Technical Bulletin

NP01	TB008-2022 Rev B	SEBECO MOTORSPORT	
From:	Ben Cooper– Project Engineer, NP01		
Subject :	Drive Shaft Length	Date:	2/2/22

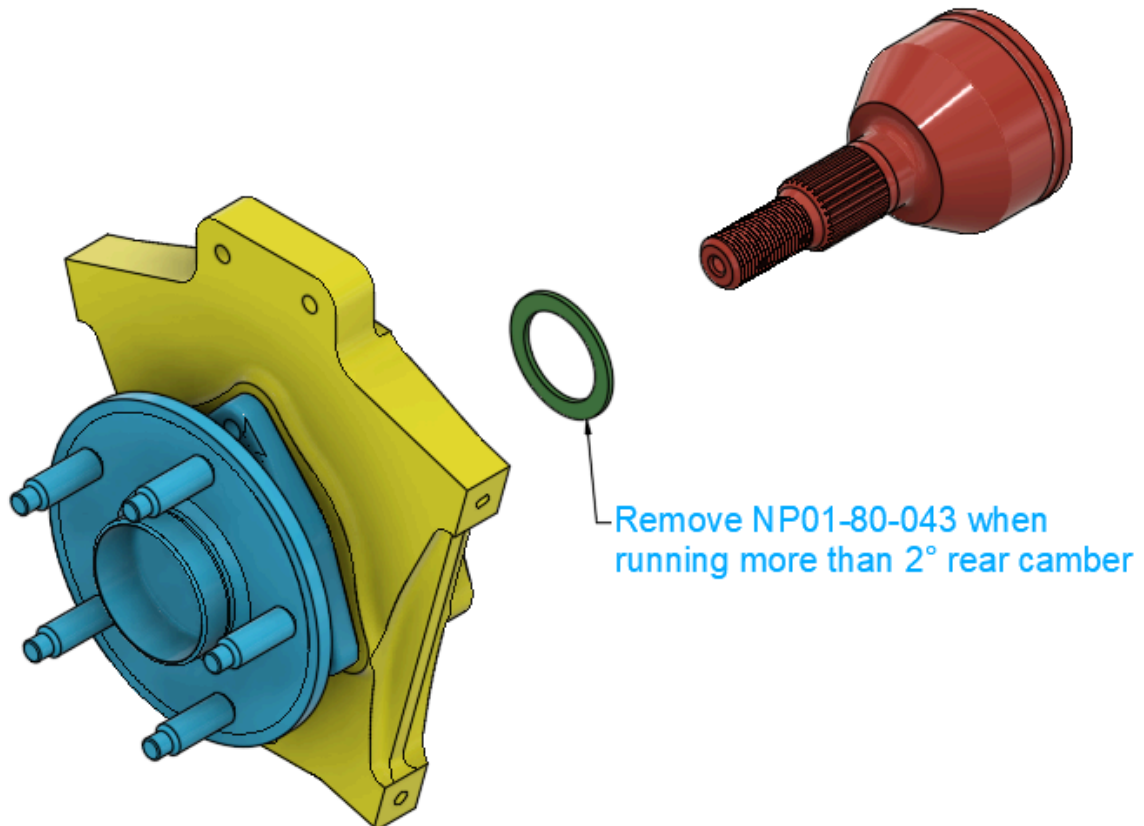
It has been found that running less than 2° rear camber the inner tripod joint can make contact with the boot flange that is bolted to the tripod cup.

In this situation it is possible that the inner CV runs out of travel and can pop the inner CV housing out of its internal C clip groove resulting in driveshaft vibration. It should be noted that the car should never be run statically with the rear wheels/tires off the ground and in gear with 2° or less rear camber. This is the very worst-case scenario for the driveshaft.

The solution is a steel 0.1” shim that will be added between the outboard end of the CV and the wheel hub bearing. This effectively moves the inner CV inboard and away from its current limitation in full suspension droop.

This shim is part number NP01-80-043 and is available from Sebeco.

Please note that when running more than 2° rear camber this shim must be removed.
